Re: 7<sup>th</sup> Street Townhomes  
SS-2003-077

**RESPONSE to REVIEW COMMENTS**  
**2nd Round**  
**7th Street Townhomes**  
**June 10, 2003**

**SUBJECT:** Response to Comments – 7th STREET  
TOWNHOMES (SS-2003-077).

SEVENTH STREET TOWNHOMES  
SITE PLAN

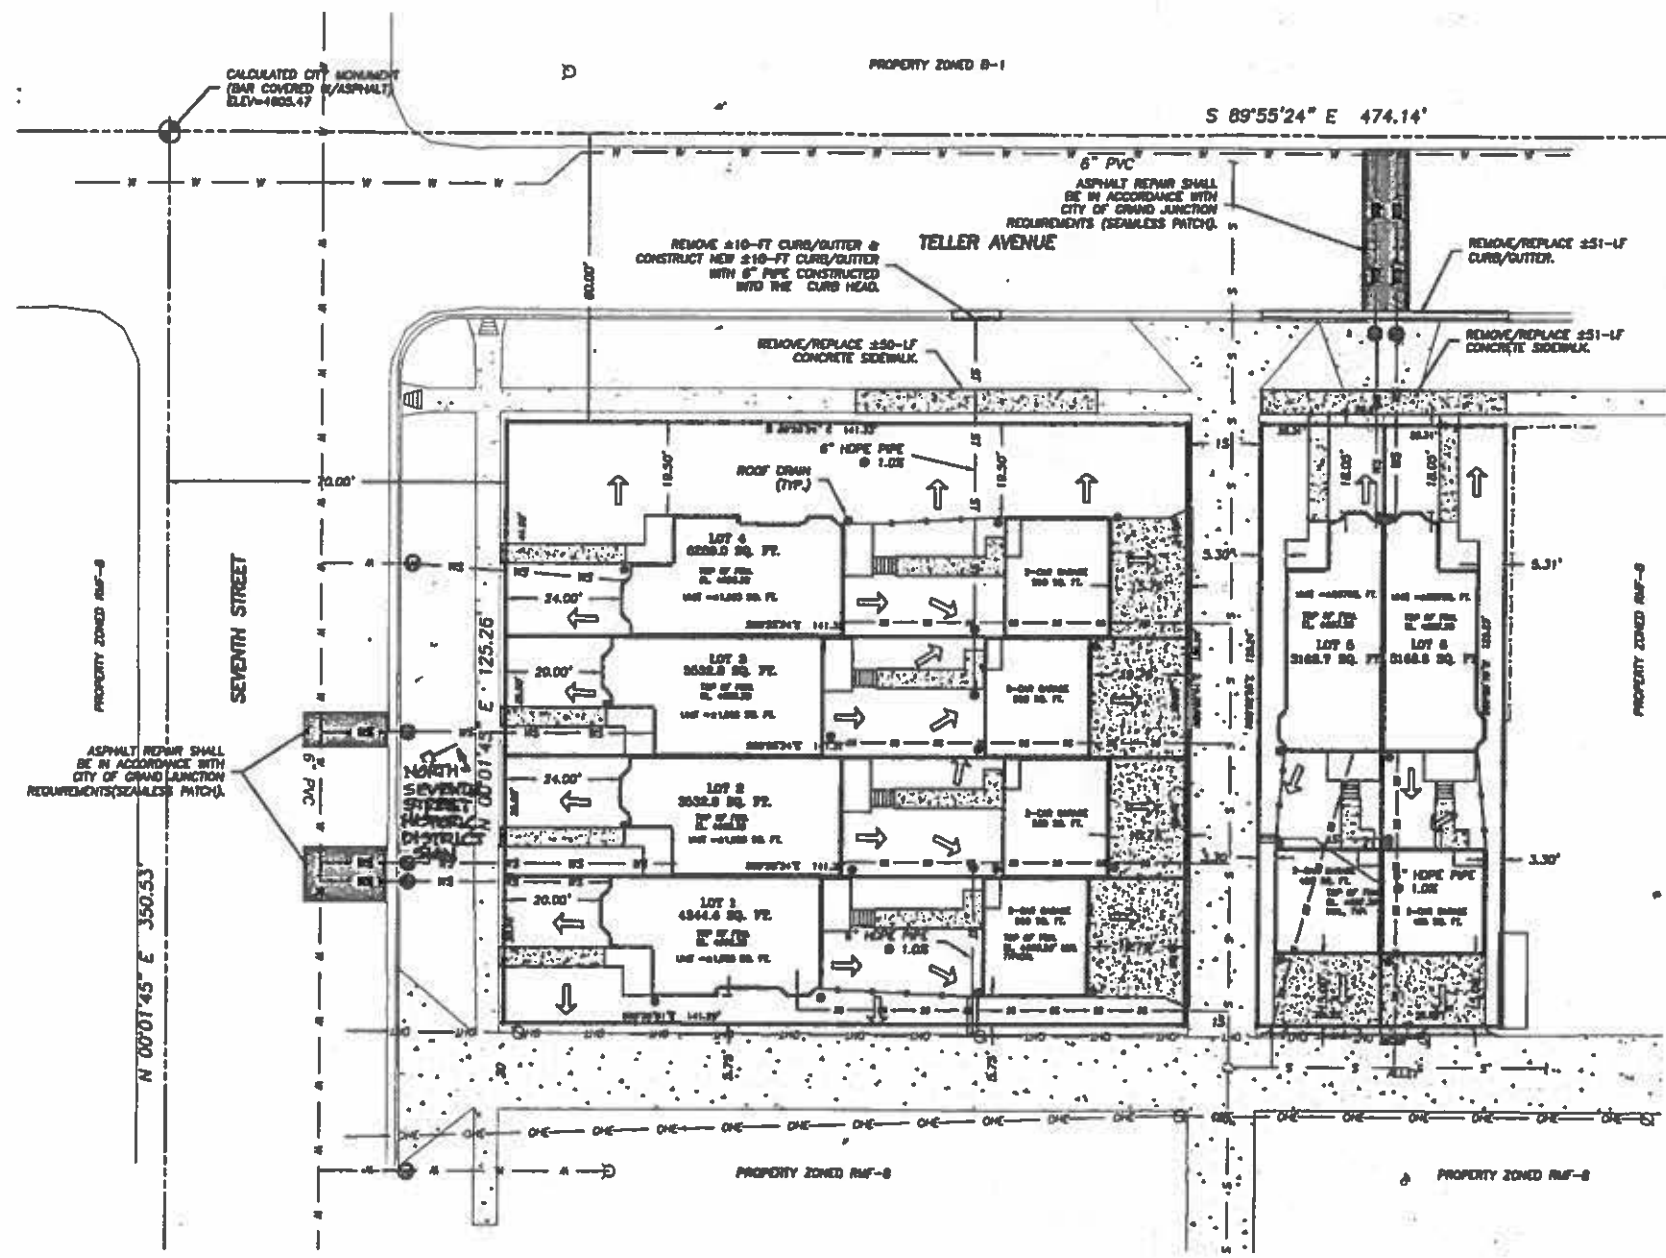
1. The 11X17 copy of the site plan does not match the utility composite for utilities. Make them match.  
*Response: The site plan has been revised.*
2. The asphalt patches must use seamless patching. Please call this out.  
*Response: Seamless patching has been added to the drawings.*

5. Provide a "Site Plan" per TEDS, and include drainage flow arrows and elevations on the site plan.  
*Response: This application is a "minor" site plan review. RGCE has prepared a new site plan that we believe meet the requirements.*

SHEET NUMBER  
**47**  
**D4-262**

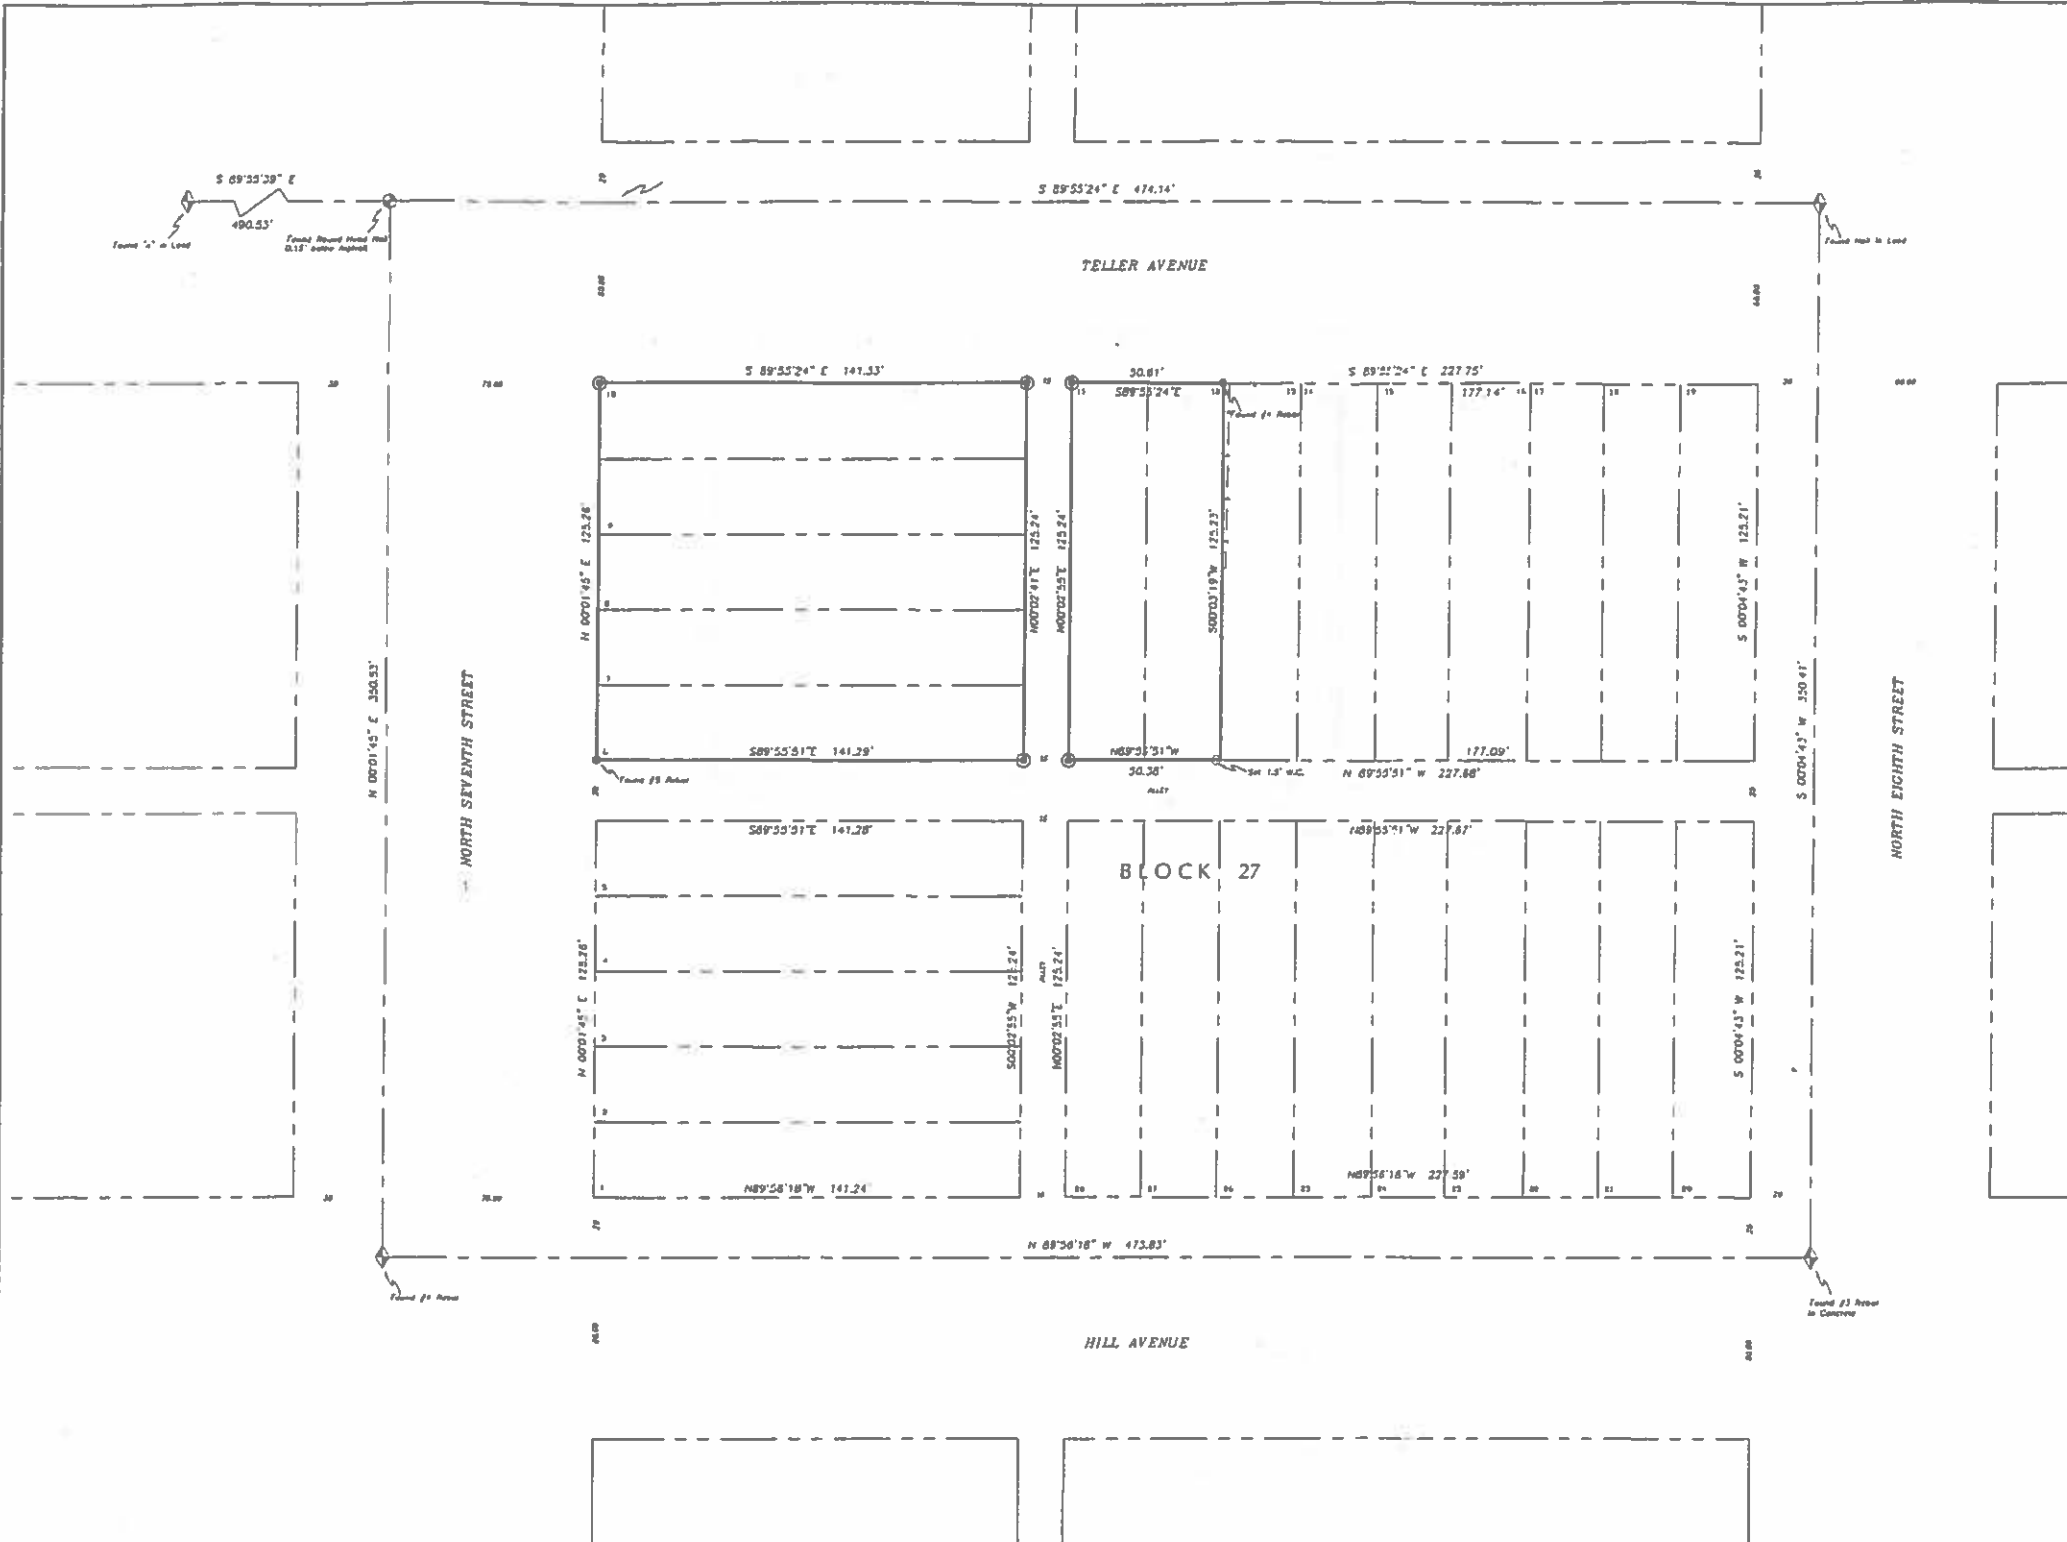
*Need Site Plan.*

- 1. Need SW removal.*
- 2. Storm pipe detail.*

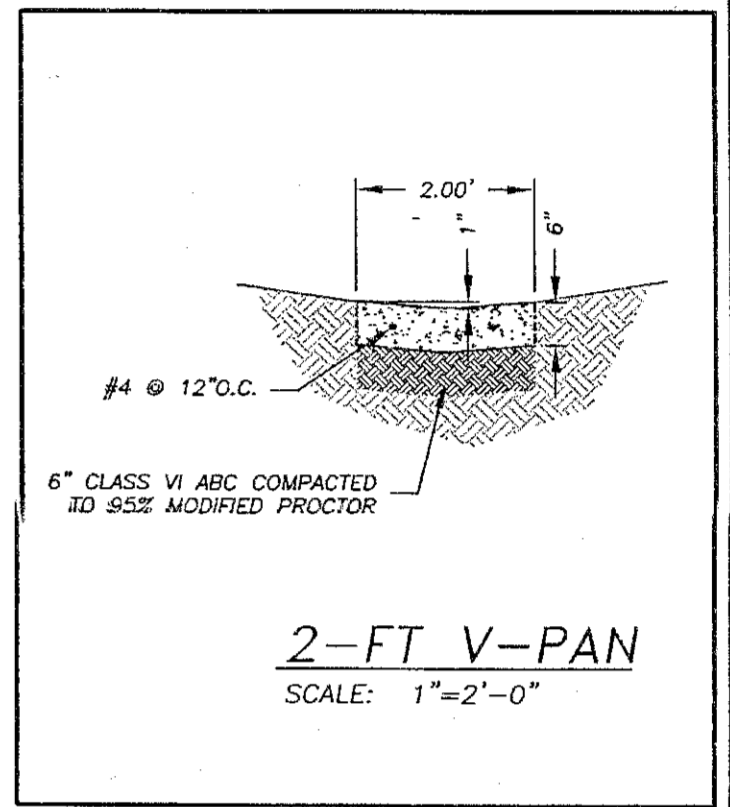
REMOVE ±10'-FT CURB/GUTTER &  
CONSTRUCT NEW ±10'-FT CURB/GUTTER  
WITH CHASE DRAIN. SEE DETAIL ON S-1.

51'± DEMOLISH EXIST. RAMP &  
REPLACE WITH NEW SIDEWALK &  
CURB & GUTTER. REGRADE AREA  
TO MATCH NEW WORK.
